SOUTH PLANNING APPLICATIONS COMMITTEE
14 December 2015

15/02822/FUL and 15/02823/CON: Reidhaven Estate
14-16 The Square, Grantown-on-Spey

Report by Area Planning Manager - South

Description: Demolition of building to rear (CON); Erection of extension to provide office & meeting accommodation (FUL)

01 PROPOSED SITE PLAN
SCALE 1:250@ A3

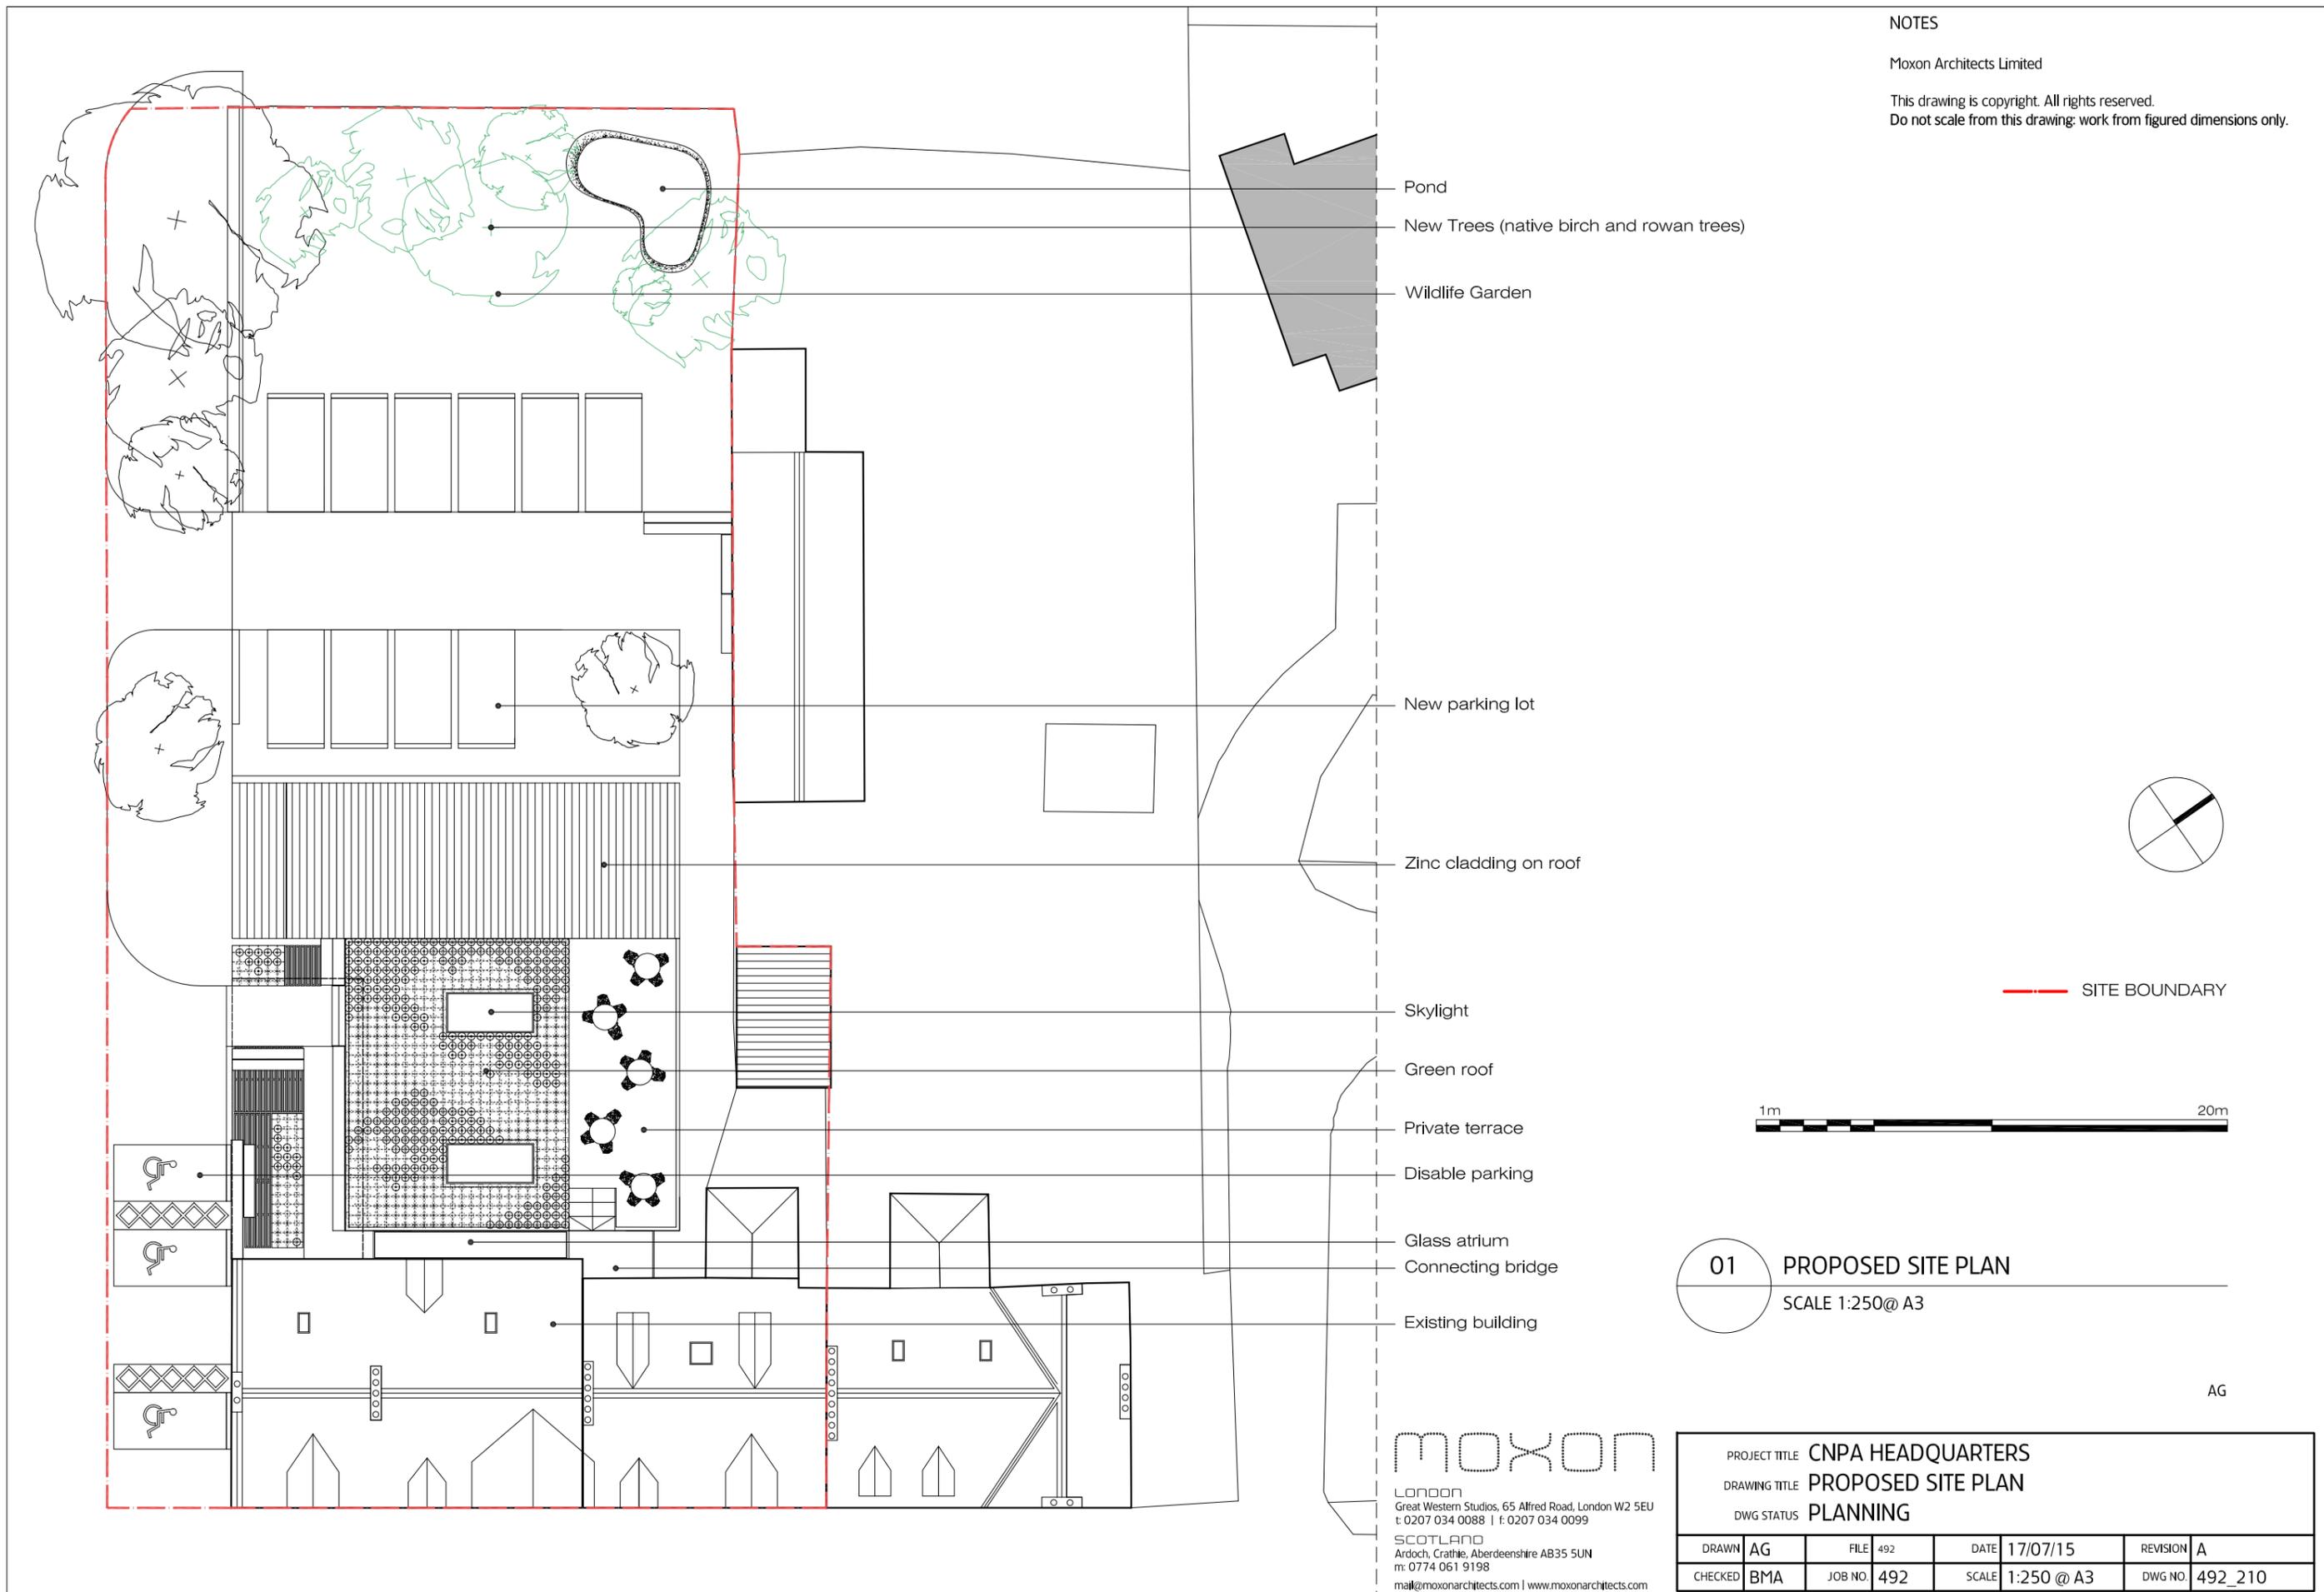
The existing approved courtyard parking layout shows seven parking spaces plus one disabled off-street. The proposed layout shows 10 off-street spaces with scope for at least two more, plus three disabled spaces adjacent to the roadside at the public entrance. Transport Planning have asked for further clarification in relation to car park dimensions and cycle storage provision and these are matters that can be addressed through conditions.

5. No development or works shall commence until full details of the layout and dimensions of the off-street parking areas and the provision of cycle storage facilities have been submitted to, and approved in writing by, the Planning Authority.

01 PROPOSED SOUTH-WEST ELEVATION
SCALE 1:100 @ A2

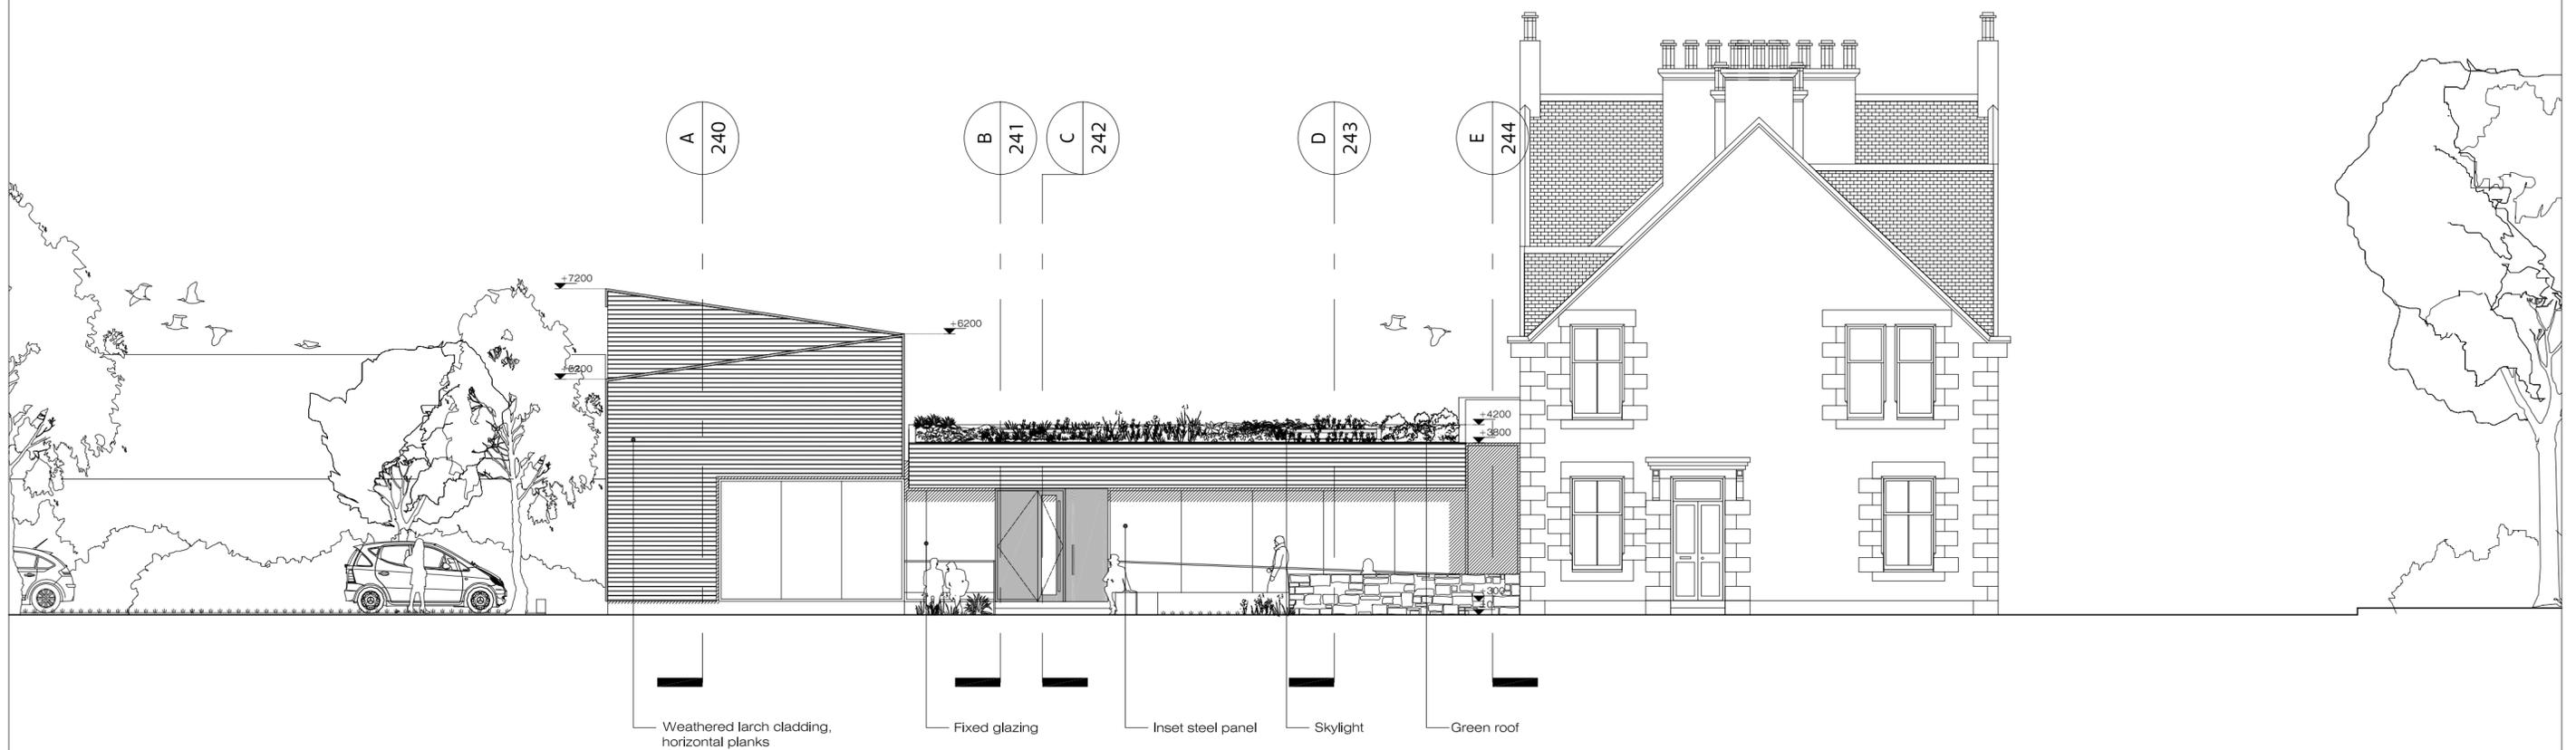
The proposed extension has been carefully designed to be a secondary building within the site respectful of its location within the streetscape. It is however considered that the boundary of the development could be strengthened to ensure that the street frontage is retained and that the strong avenue is maintained to preserve and enhance the streetscape. This can be addressed by condition.

4. No development or works shall commence until full details of an additional boundary wall which shall be constructed using stone salvaged from the demolition of the existing extension, and which is to be erected adjacent to the south west gable of the two storey extension, have been submitted to, and approved in writing by, the Planning Authority. Thereafter, the wall (including the section shown on approved drawing number 492_230 Rev. A) shall be completed prior to first occupation of the new extension.
